TRUCK SERVICE BULLETIN

NO. T-8-201

Subject: VALVE ROCKER ARM SHAFT AND BRACKET ASSEMBLY

Models: 228, 236, 248 AND 270 ENGINES

Figure 2 - Diagram Showing Current Method of Lubricating Distributor Gear, with Possible Parts Combinations.

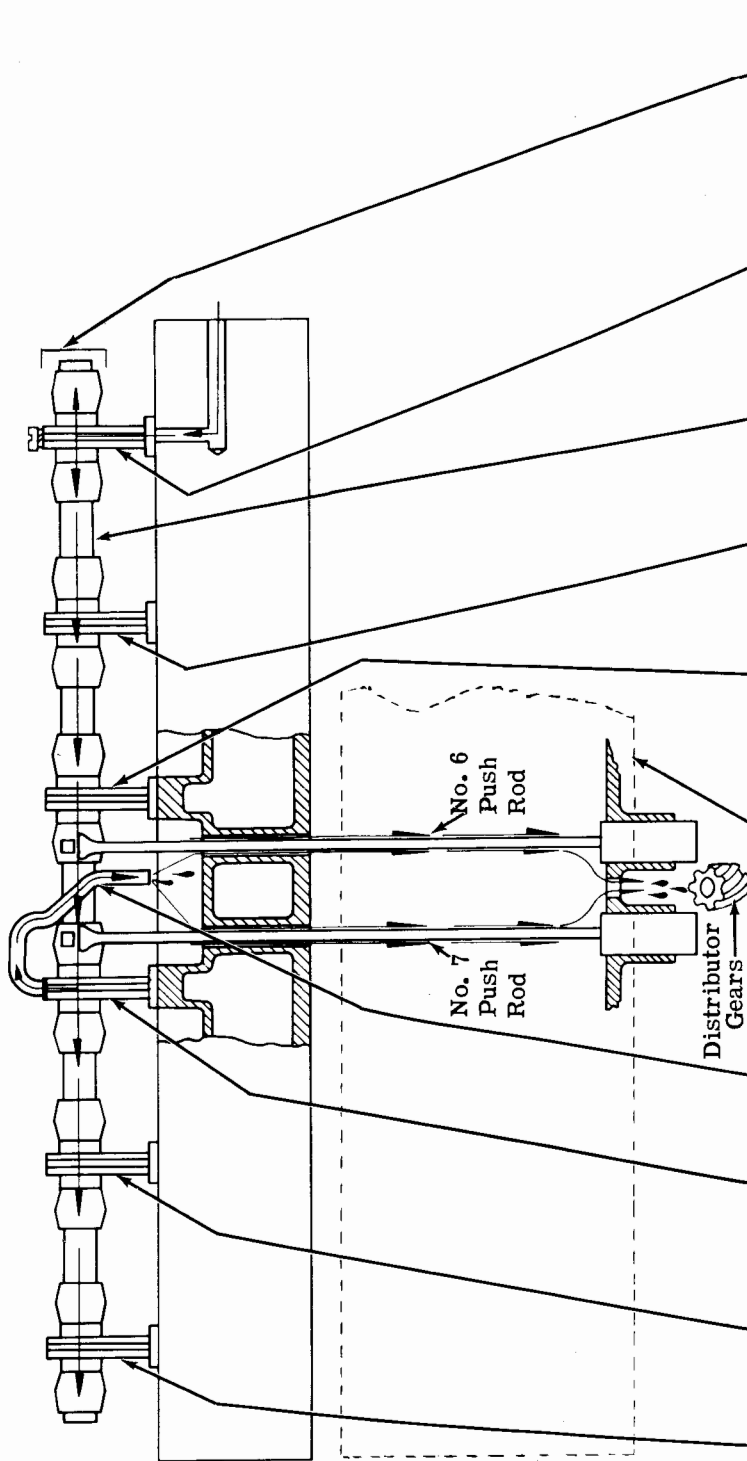
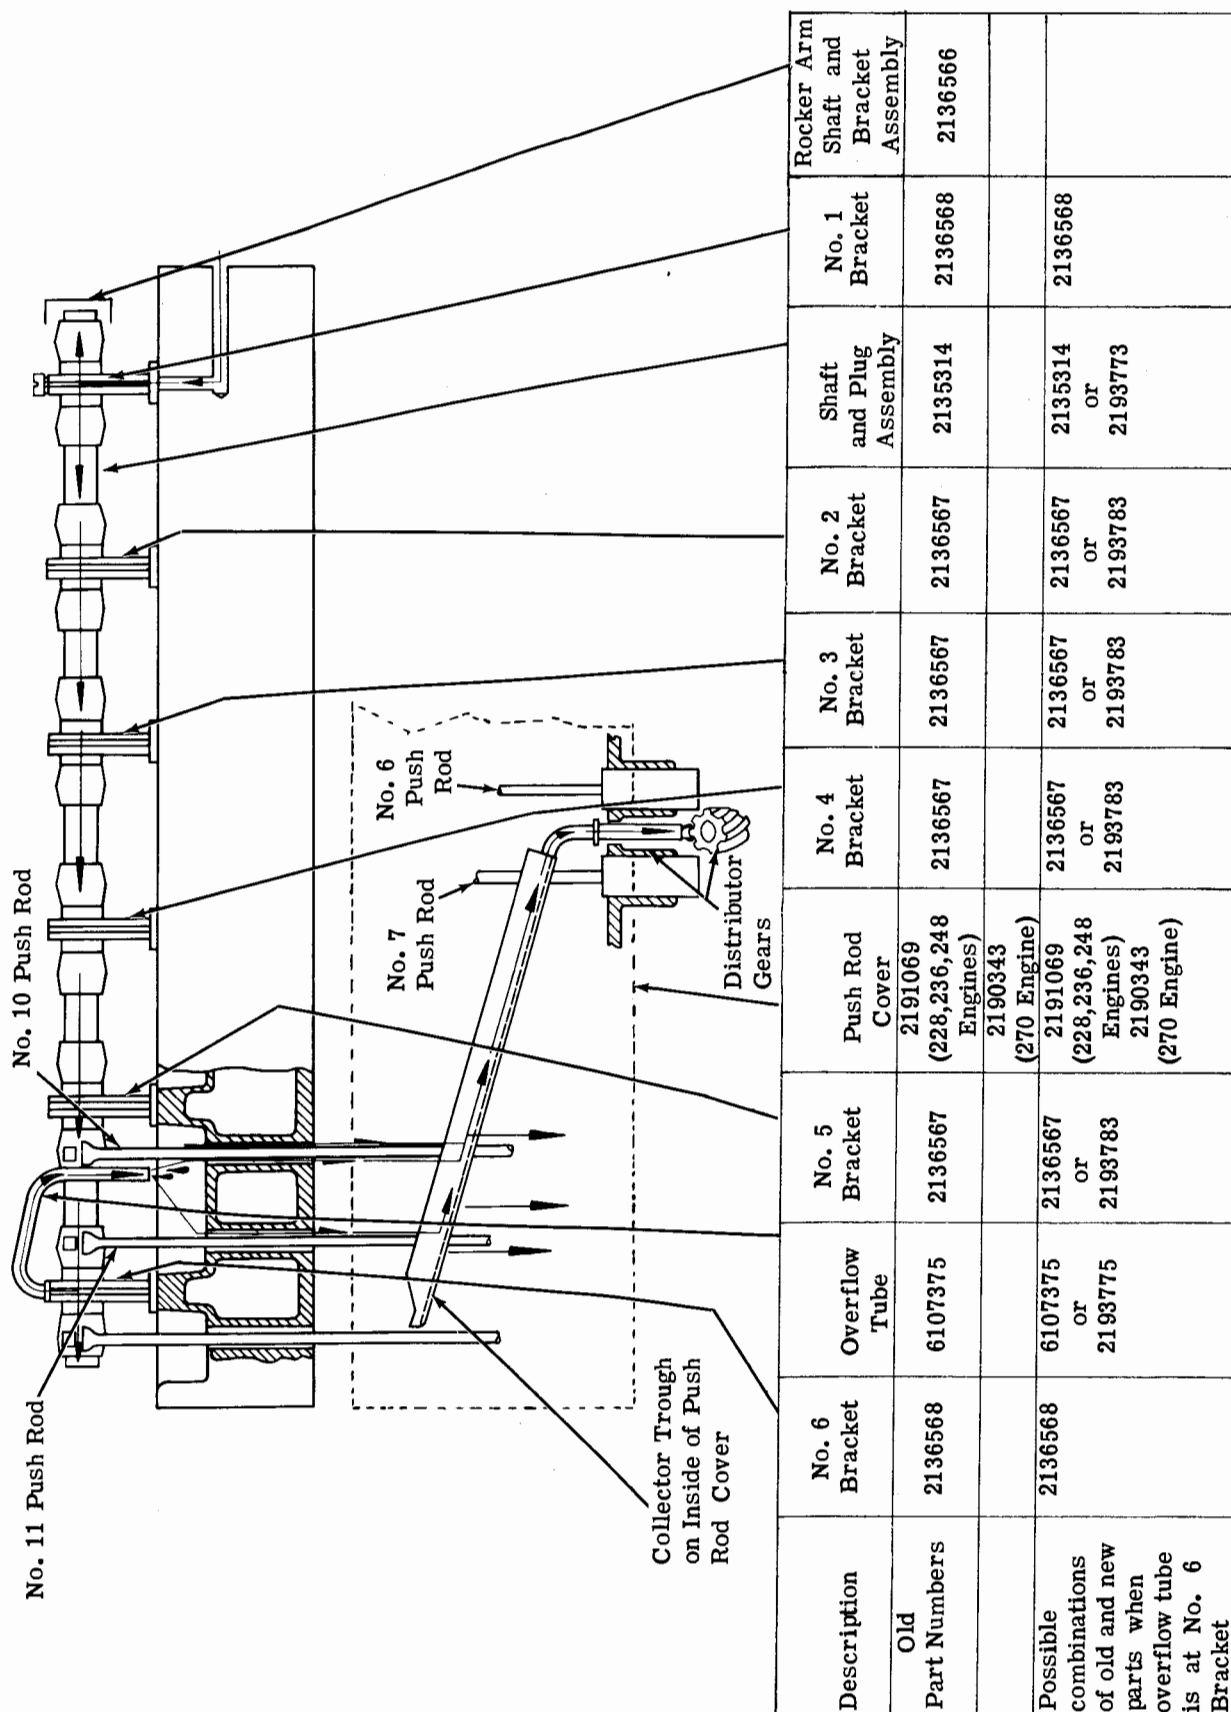
In subject engines prior to 1950, excess oil from the valve rocker arm shaft passes through an overflow tube which is attached to the rear (No. 6) valve rocker arm shaft bracket.

Oil then flows down by the No. 10 and 11 push rods and is collected in a trough attached to the inside of the push rod cover. A tube on the end of the trough directs the oil down a hole drilled in the block between No. 6 and 7 push rods, directly above the distributor drive gears as shown in Figure 1.

Beginning with 1950 vehicles, subject engines current in production have the overflow tube attached to the No. 4 valve rocker arm shaft bracket. A new rocker arm shaft is used having an oil outlet hole located to correspond with the number four bracket position. Overflow oil from the tube now passes down along the No. 6 and 7 push rods and through the hole in the block to the distributor gears. Refer to Figure 2.

In addition to the new rocker arm shaft, the latest arrangements includes new overflow tube, new No. 2, 3, 5 and 6 rocker arm shaft brackets and the use of the former No. 6 rocker arm shaft bracket in the number 4 position. A new push rod cover which does not incorporate a collector trough is used.

a. The new rocker arm shaft and bracket assembly #2193772 has the oil overflow return tube bracket located at the No. 4 position rather than at No. 6 position, as in the old assembly.

b. The new shaft #2193773 may be identified by four 13/64" holes which are drilled in line on top side of shaft only. The original shaft has two 13/64" holes, otherwise shafts are identical.

The new rocker arm, shaft and bracket assembly may be used to replace the original assembly by also using new overflow tube and either using new push rod cover, or reworking old cover as shown in Figure 3.

Otherwise various combinations of old and new parts may be used until old stock is exhausted, depending upon the location of the overflow tube, as shown in Figures 1 and 2.

Figure 3 - View Showing Collector Trough Reworked By Removal of Oil Tube

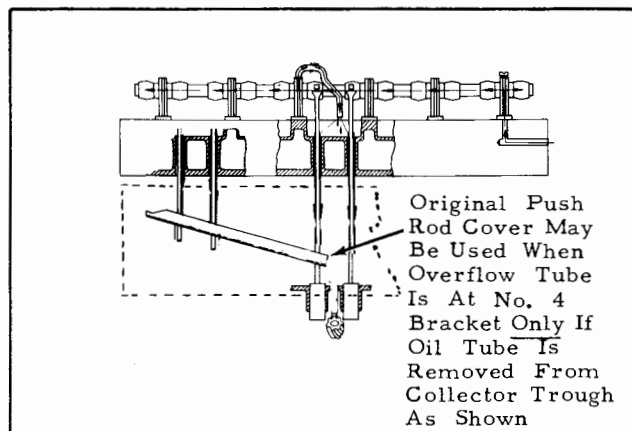
e. The latest push rod cover does not include an oil collector trough.
